CONTRACT CHANGE ORDER NO. _____
SHEET ___ OF ___

MARK	DATE	DESCRIPTIONS	BY	CH'D	CCO#
2	07/31/09	LONGITUDINAL SHEAR PLATE	DT	GB	122
1	07/30/07	HINGE A REACTION-SHEAR PLATES	DT	GB	50

SAN FRANCISCO OAKLAND BAY BRIDGE
EAST SPAN SEISMIC SAFETY PROJECT
SELF-ANCHORED SUSPENSION BRIDGE
(SUPERSTRUCTURE & TOWER)

GIRDER AT EAST TRANSITION NO.15

ELEVATION
LONGITUDINAL SHEAR PLATE TYPE 2
SECTION B-B

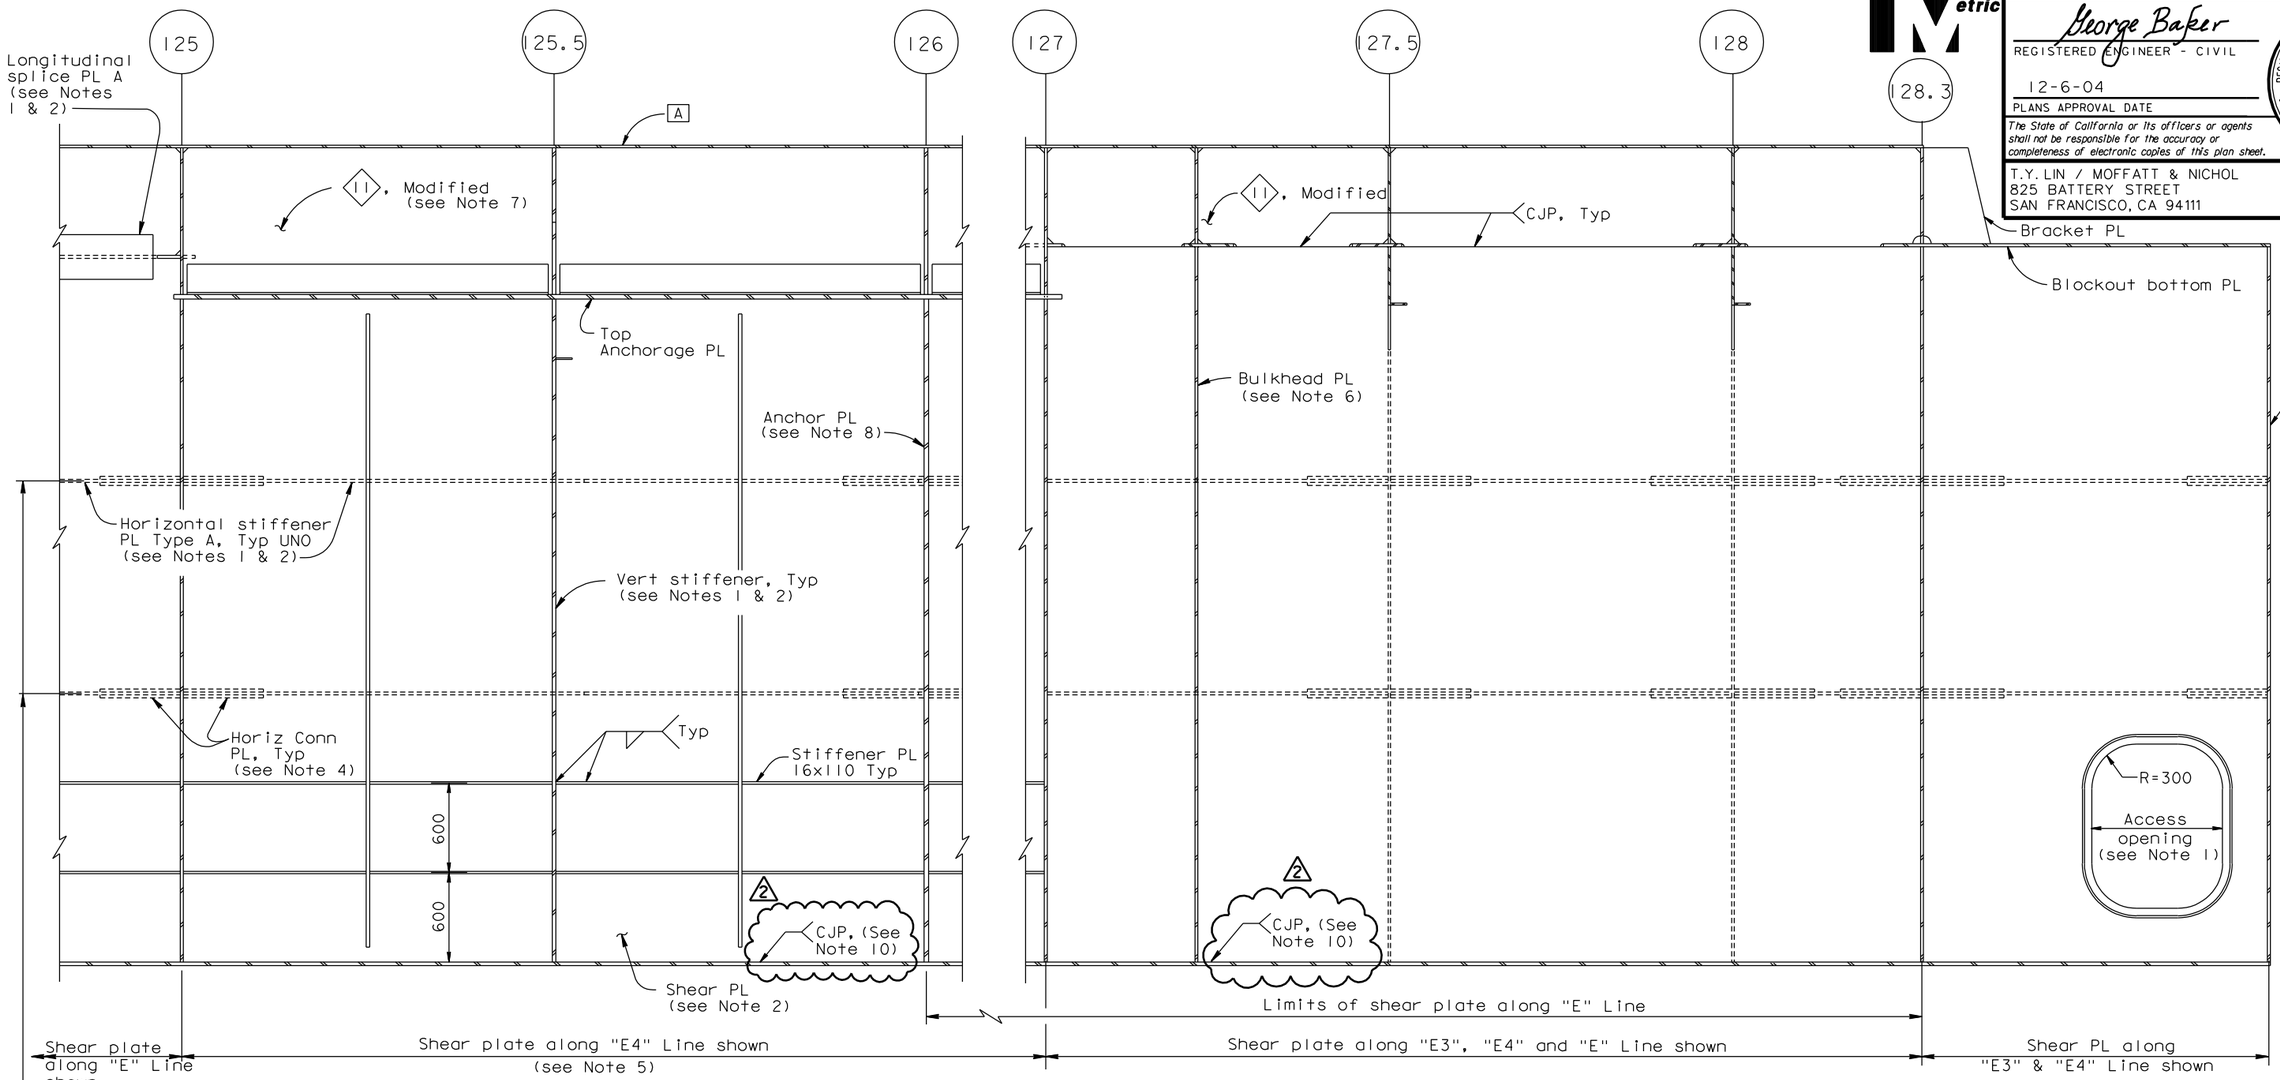
10. (2) The Longitudinal Shear Plate to Girder Face "D" weld shall be a CJP from the CL Splice near PP111 to PP128.7.
